RE: Additional Information Requested for Amendment to Registration for Registry #NR-122-D-101-S

This is the response to your request dated March 28, 1996 for additional information for the amendment to the above referenced documents. Each item is addressed in the same order as your letter. Our response is as follows:

ATTACHMENT #1

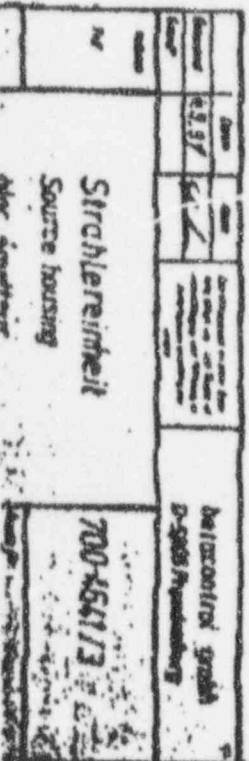
1. We verify that no design changes have been made between the specifically licensed (SL) devices and the generally licensed (GL) devices.
2. Attached is a text of the GL label (Attachment #1) that will be placed on the GL devices. The location is identified on the attached drawing. We verify that the GL label will not be placed on SL devices. These labels will be attached by rivets or screws.
